Subject: Transmittal Letter – Errata and Addenda for Revision 1 of the April 2013 Mt. Taylor Mine Closeout Closure Plan and Revision 1 of the Application for Revision of Mine Permit to Active Status

ADDENDUM #1

APPLICATION FOR REVISION OF MINE PERMIT #C1002RE FROM STANDBY TO ACTIVE STATUS AND MODIFICATION OF GROUND WATER DISCHARGE PERMIT DP-61, MT. TAYLOR MINE, SAN MATEO, NEW MEXICO

**APPLICATION FOR REVISION OF MINE PERMIT #C1002RE FROM STANDBY TO
ACTIVE STATUS; MODIFICATION OF GROUND WATER DISCHARGE PERMIT DP-
61, MT. TAYLOR MINE, SAN MATEO, NEW MEXICO, REV.1, NOVEMBER 2013;
and**

Figure 1-6 Observation wells

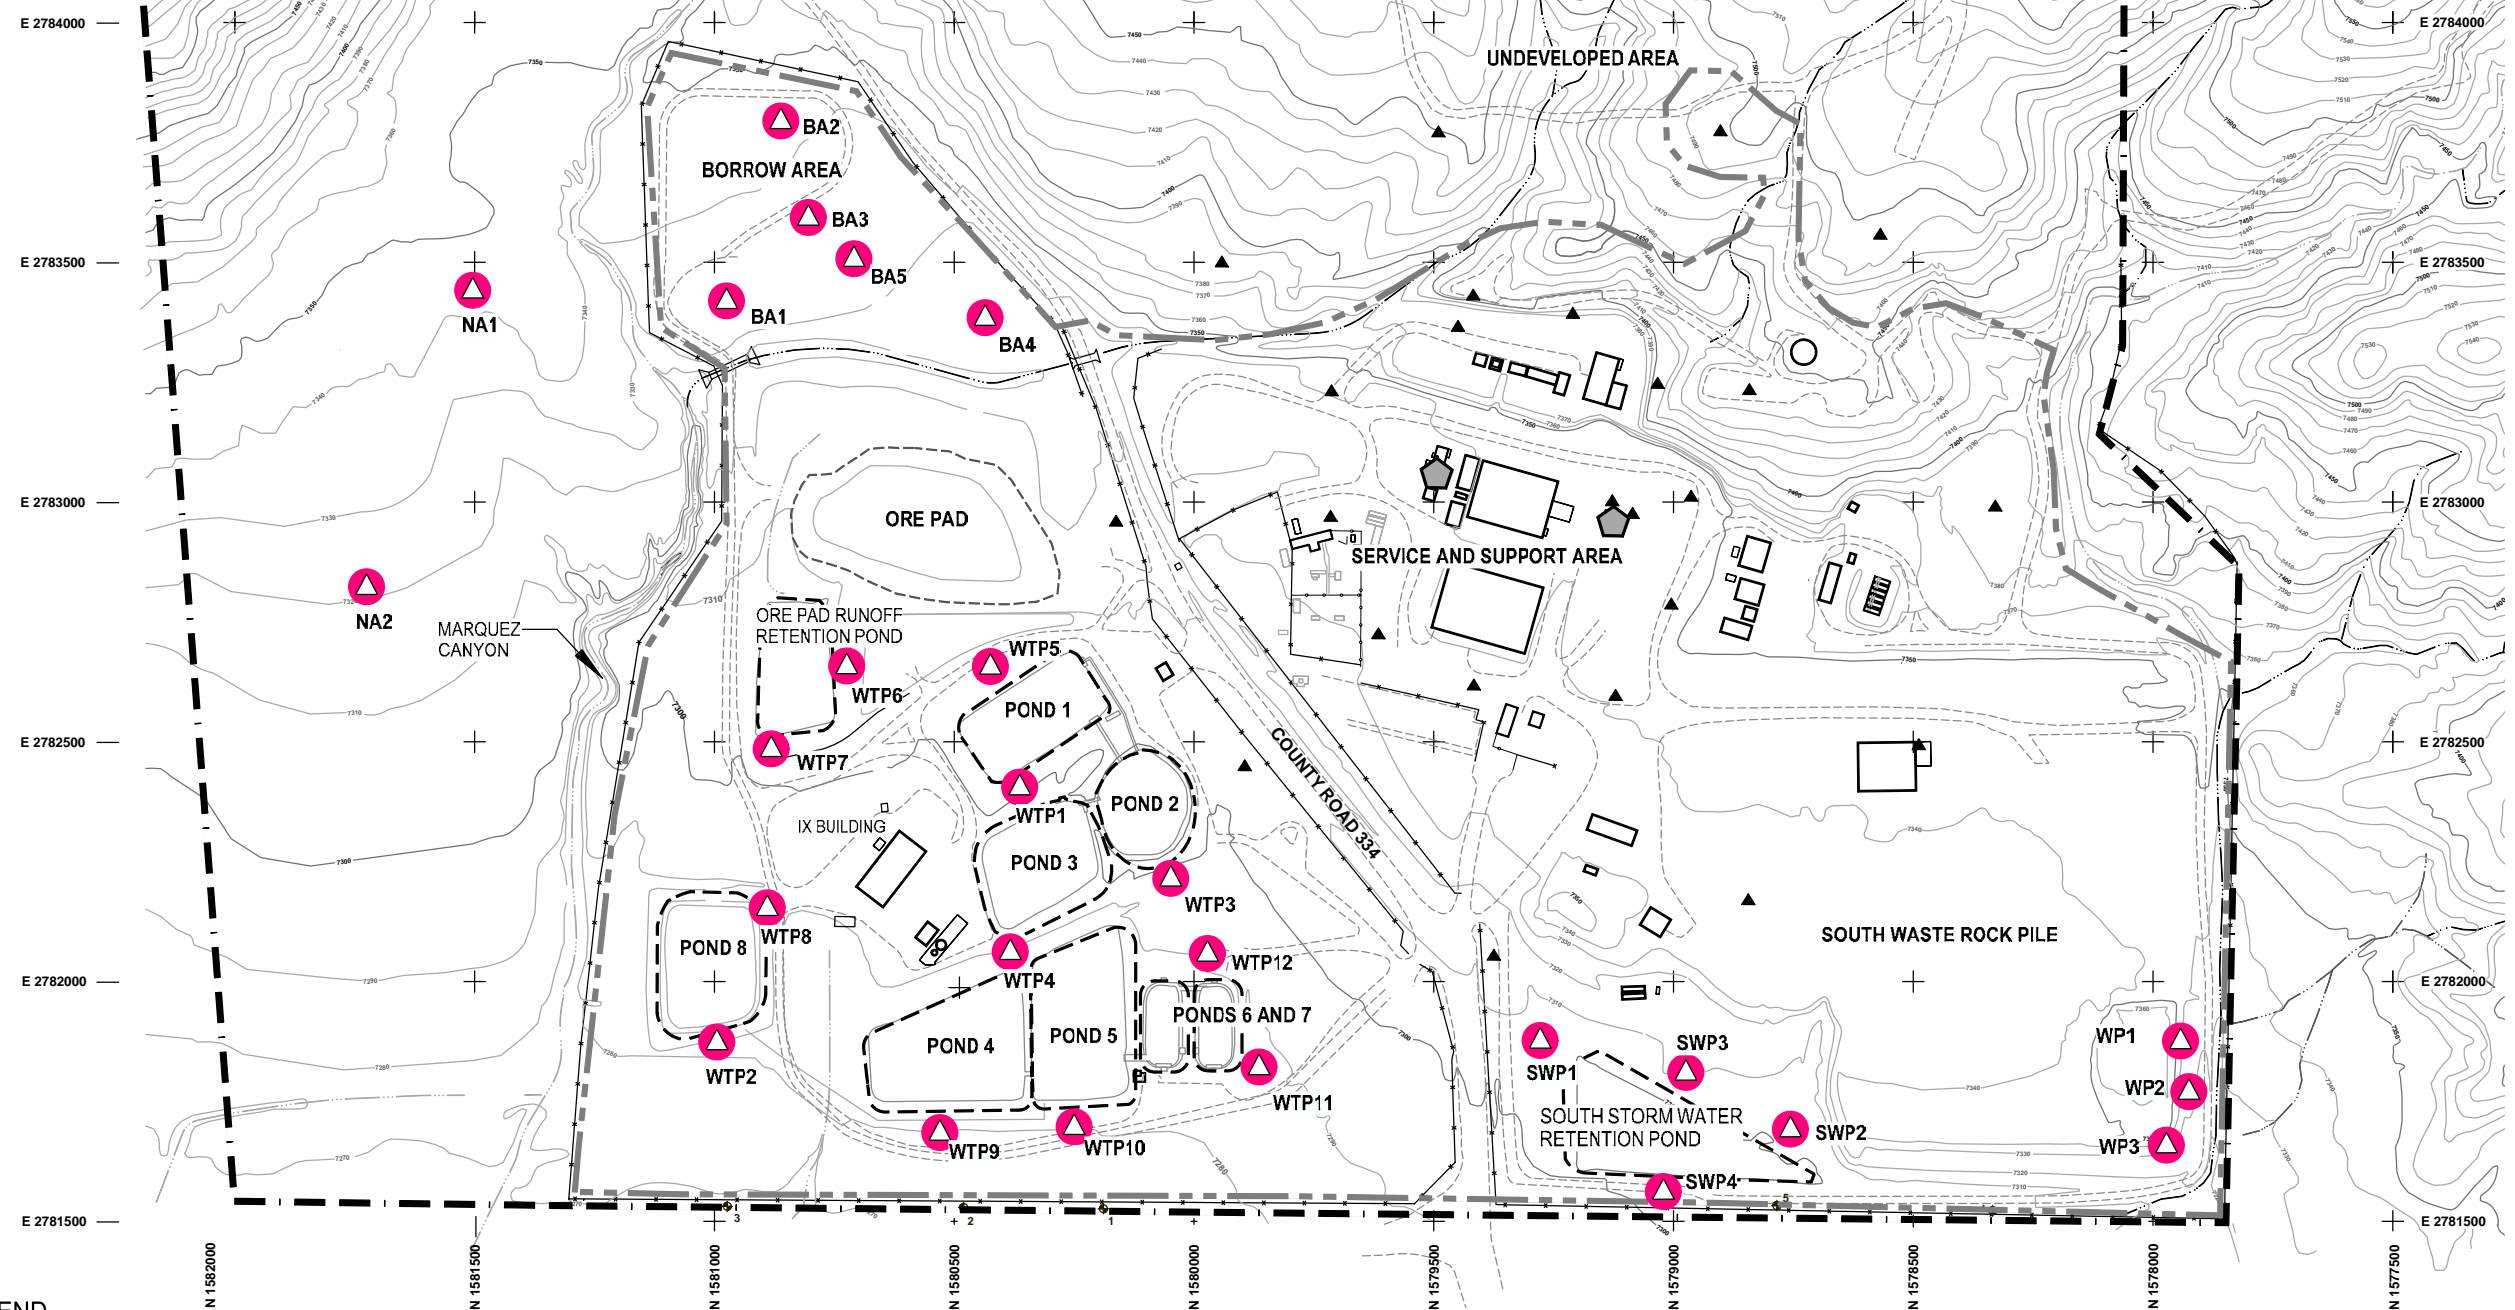
Figure 1-6

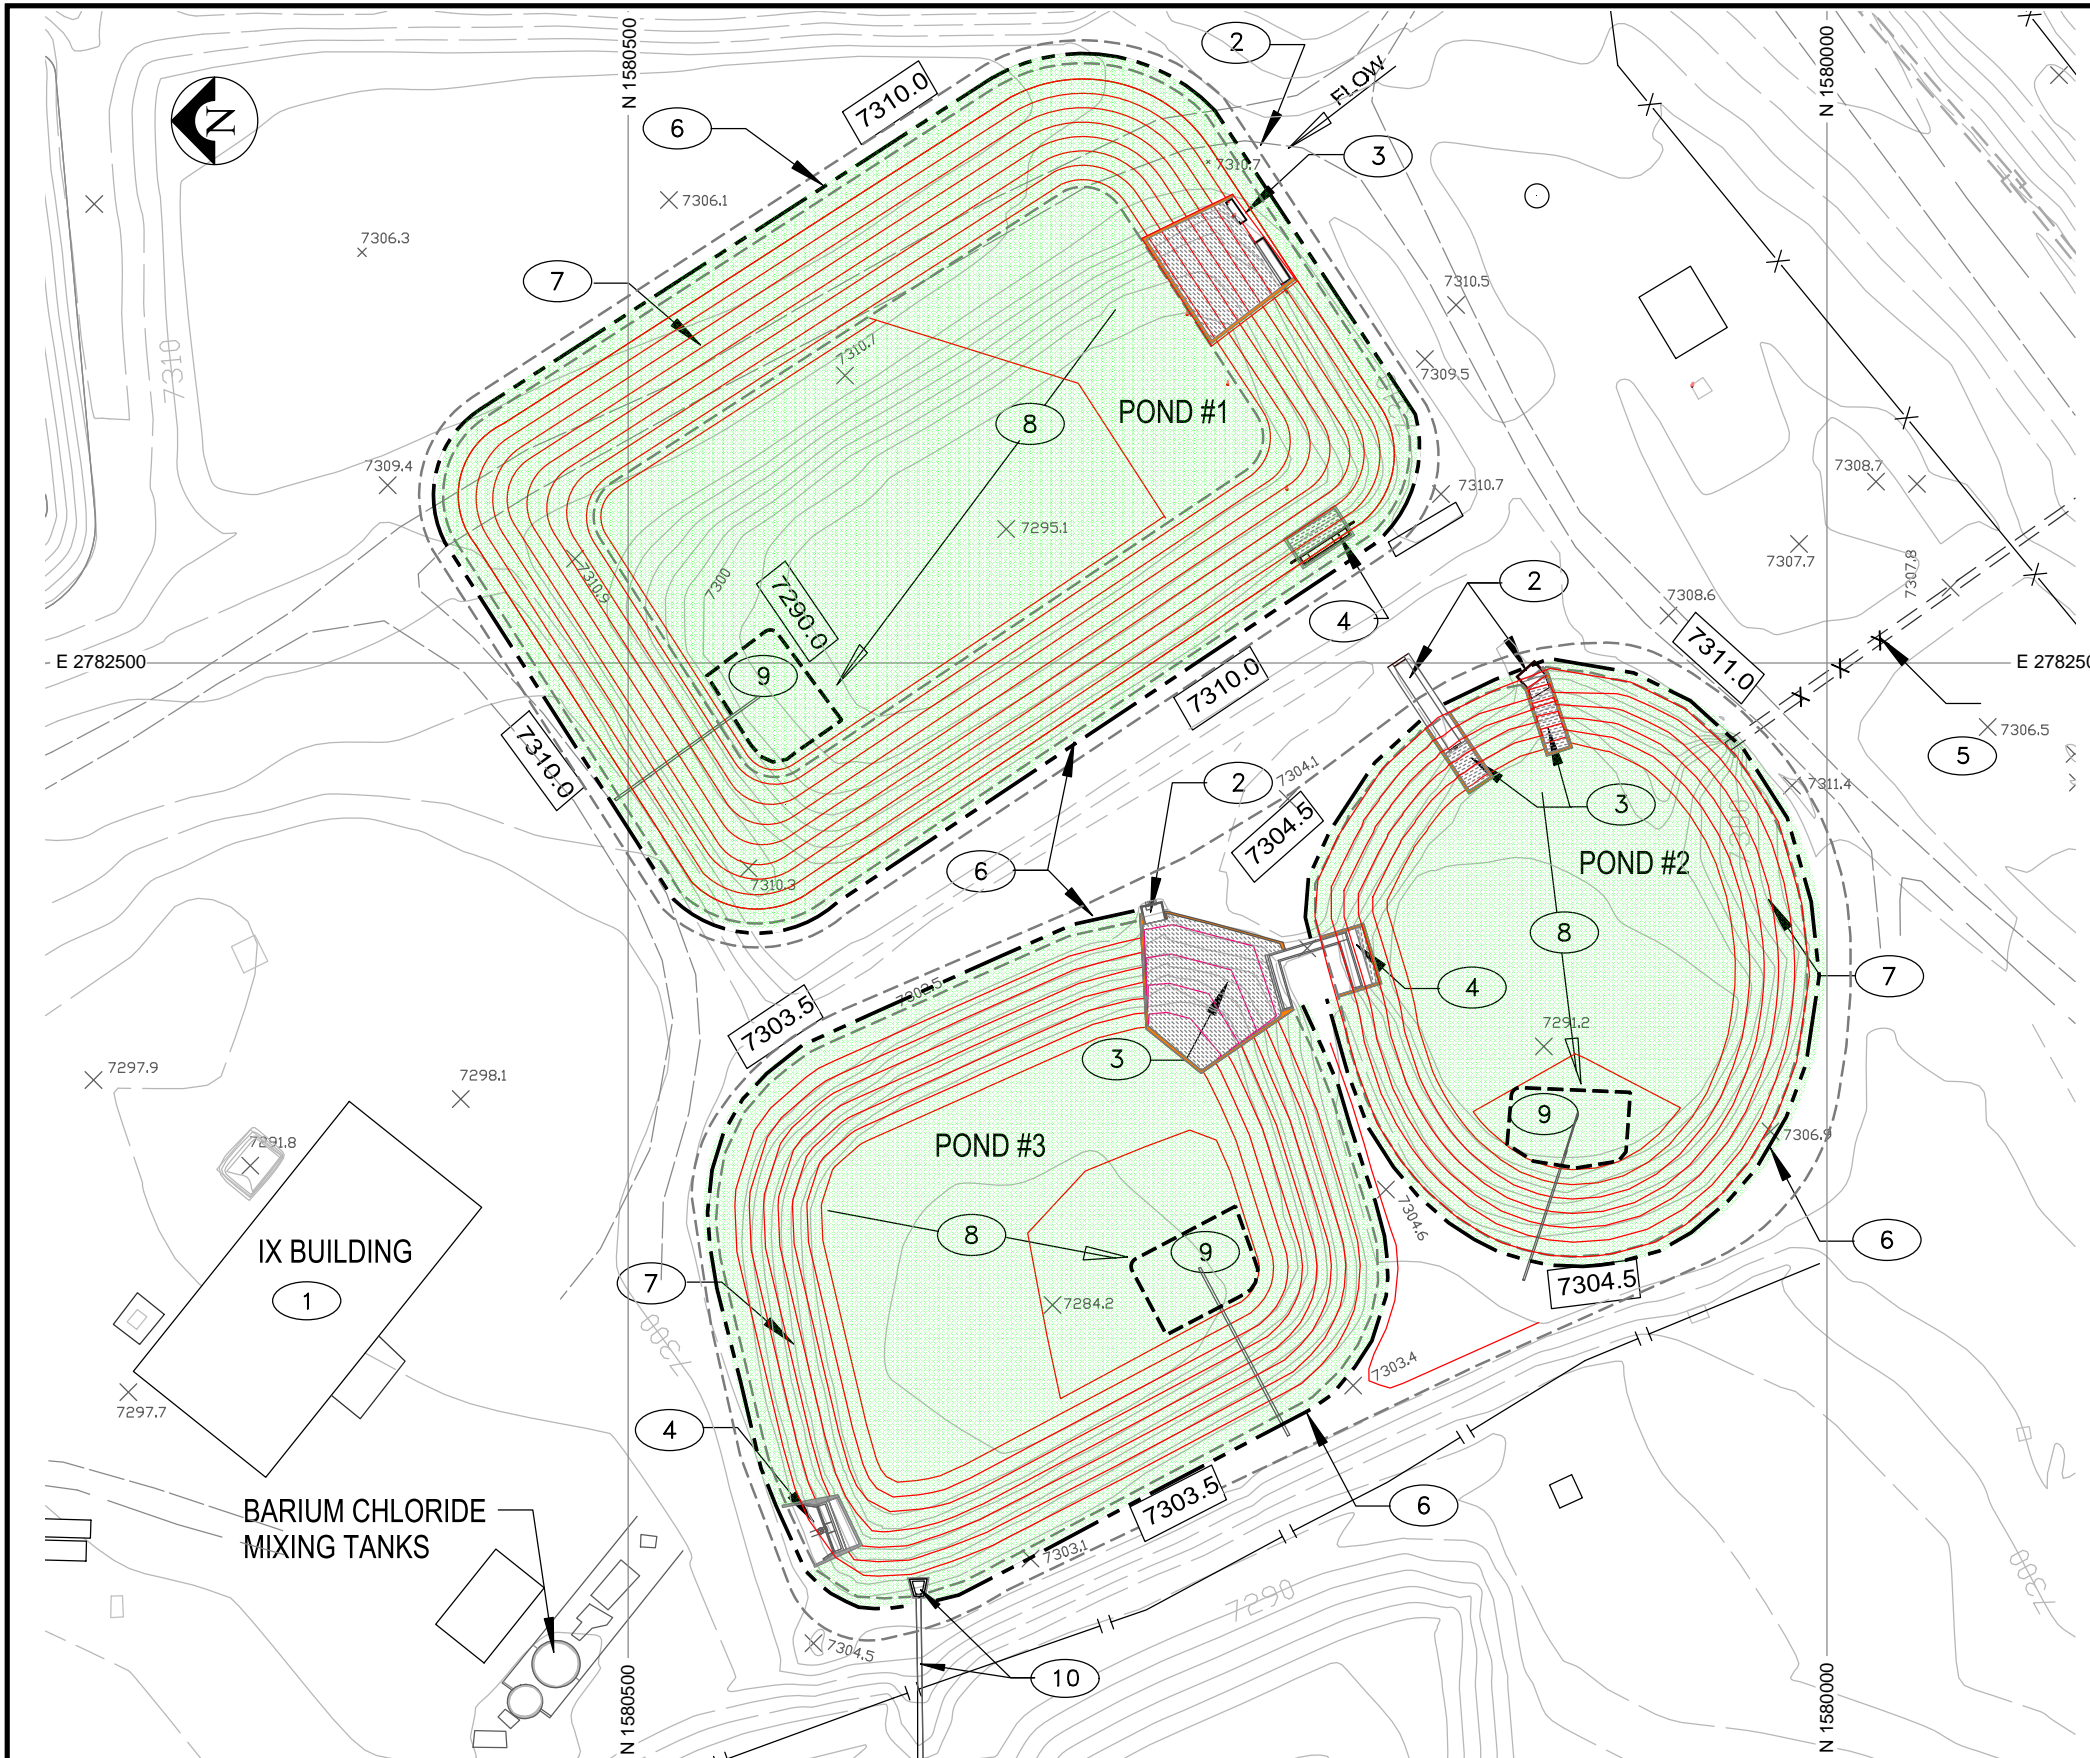
Drawing MT13-AC-03

Two coordinates labeled N 1580500 on both the east and west margins of the drawing have been corrected.

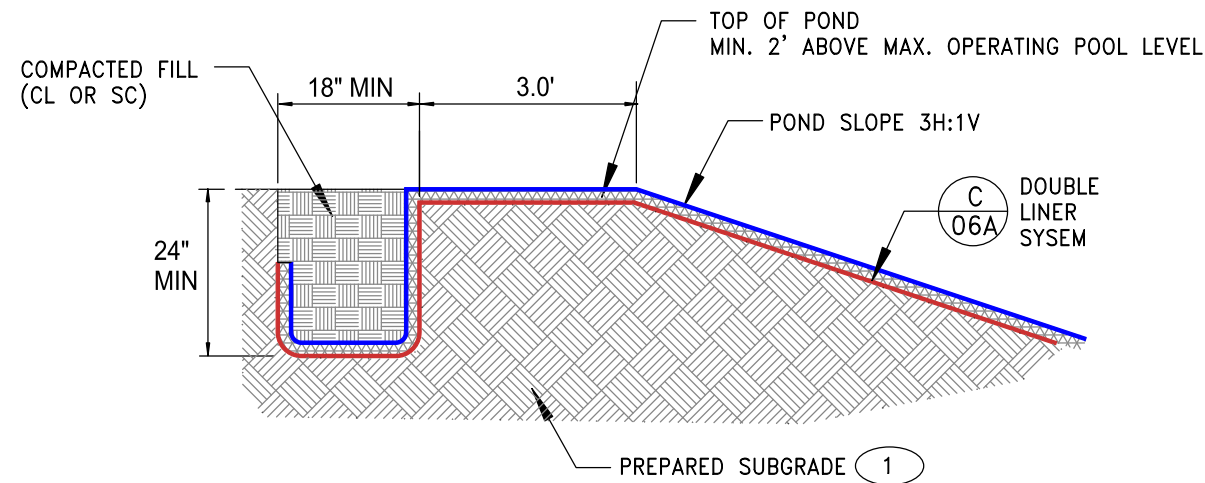
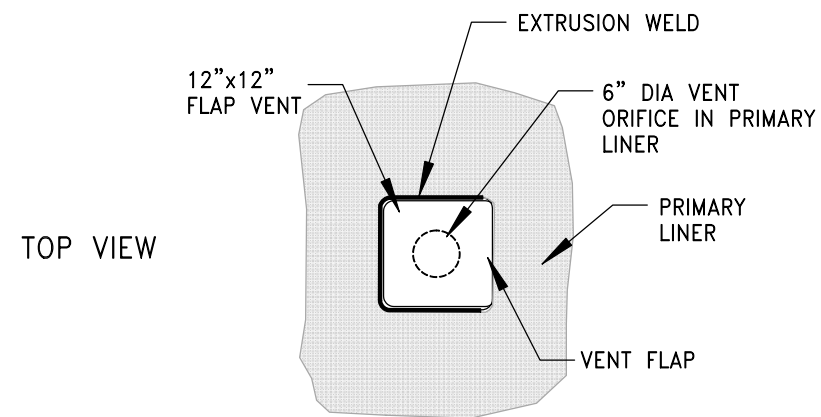
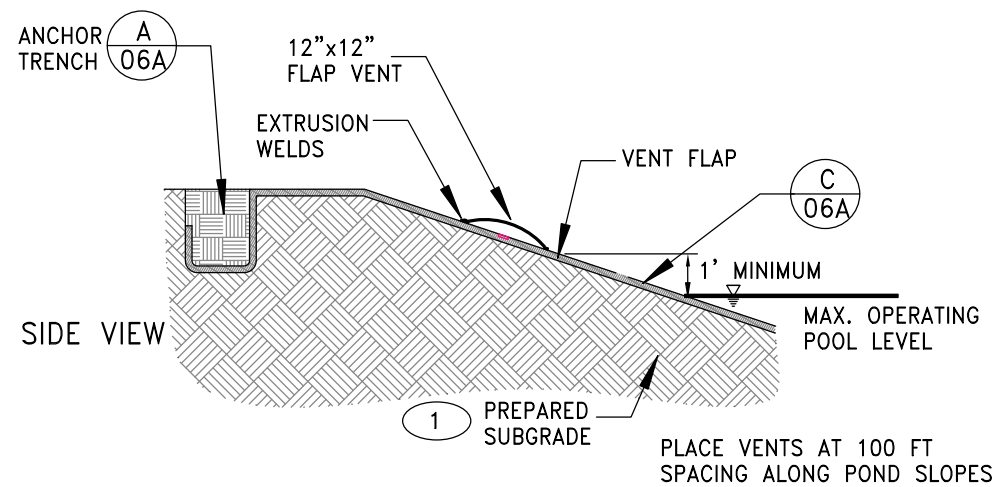
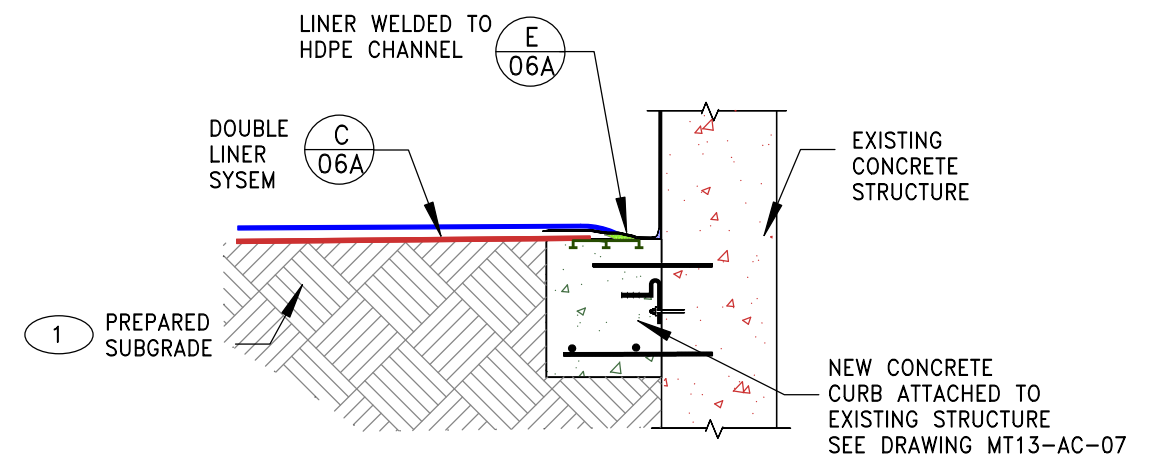
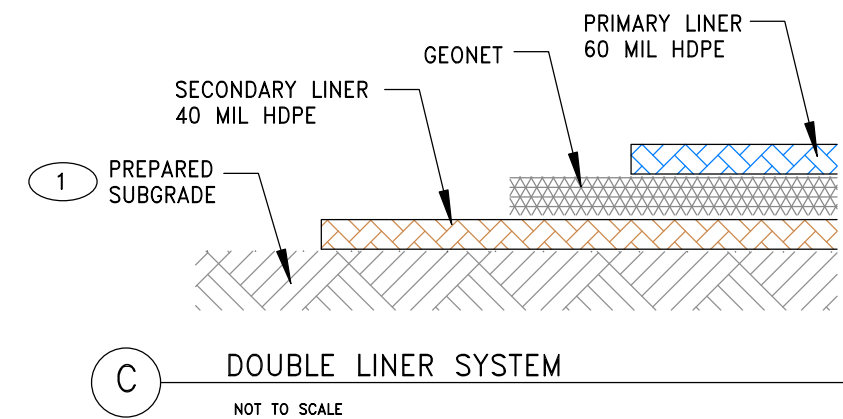
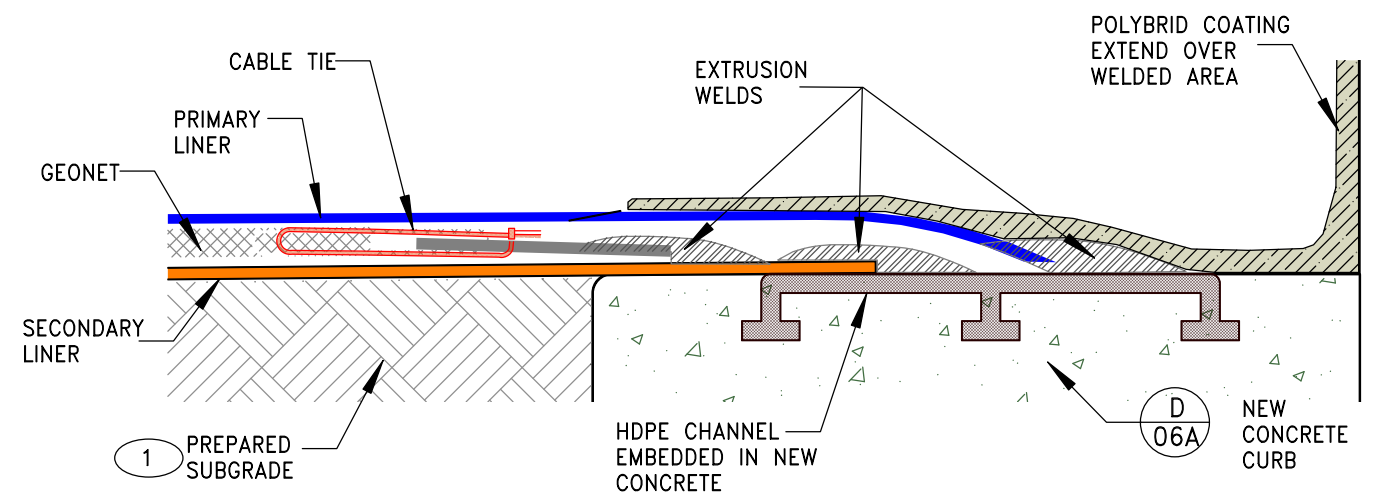
Drawing MT13-AC-06A detail C
